Southern California Edison Company

June 25, 1985

Subject: Docket No. 50-206
Seismic Analyses
San Onofre Nuclear Generating Station
Unit 1

REVIEW OF NRC PROPOSED ANALYSIS
METHODOLOGY AND CRITERIA

FIGURE 1 (FSA FIGURE 9.2)

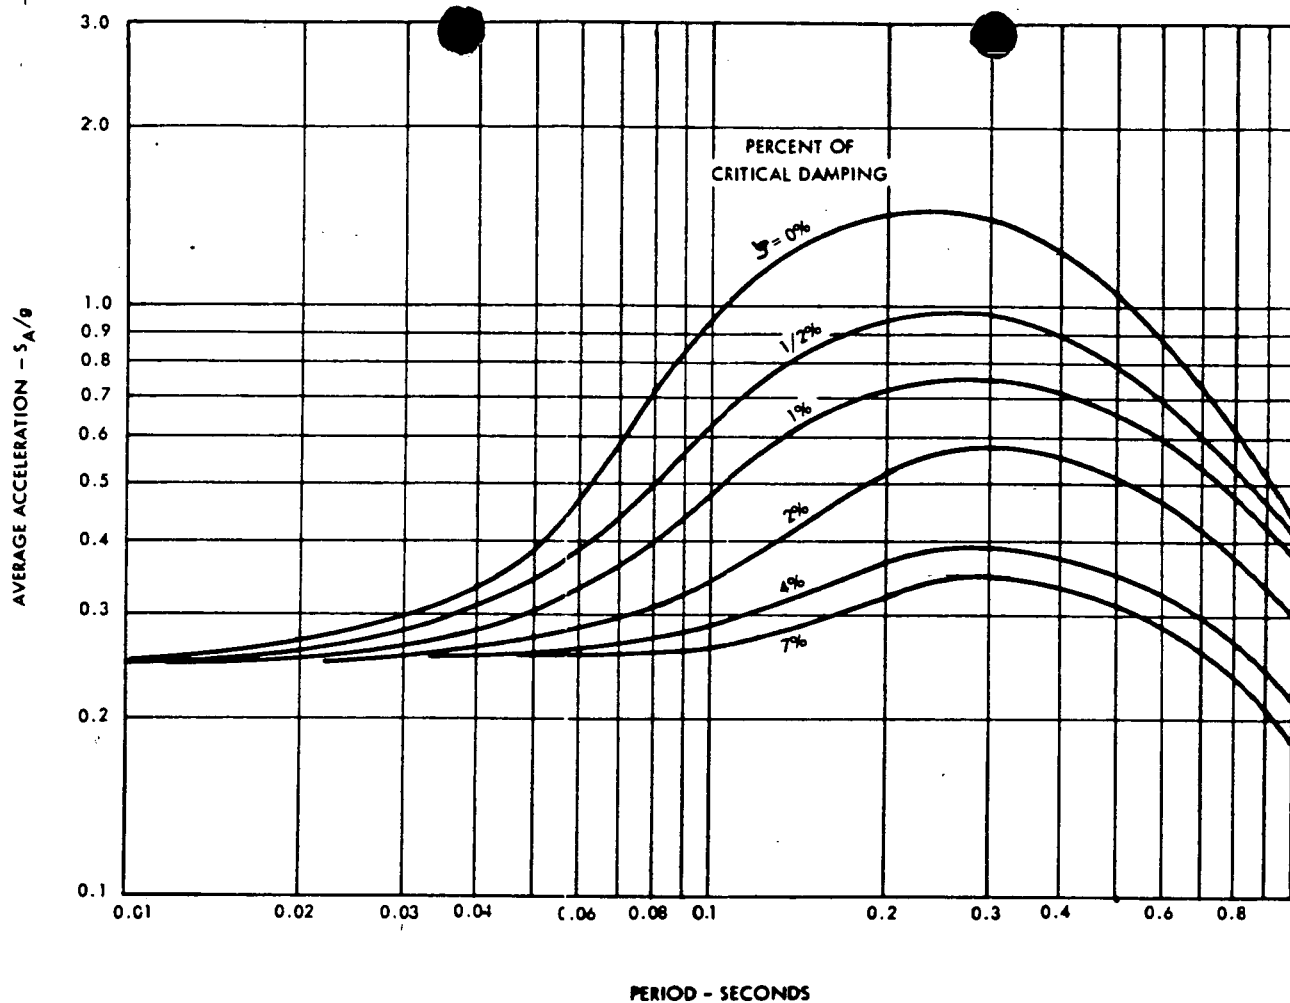
- o Design Spectrum: Figure 1, which is Figure 9.2 of the SONGS 1 FSA, shows a log-log plot of the acceleration response spectra normalized to a maximum ground acceleration of 0.25 g for various percentages of critical damping. The input data for these curves were developed by Dr. G. W. Housner. These curves cover periods from 0.01 to 1.0 second and damping factors of one-half percent to seven percent. The horizontal component of the ground acceleration was taken directly from the curves of Figure 1 and the vertical component was taken as two-thirds of this value.

Since the peak acceleration for 1/2% damping, as shown in Figure 1, is only one g, piping stress allowables shall govern the analysis of piping systems in which valves are included and where no purchase specification or vendor specifications are available that specify lower accelerations.
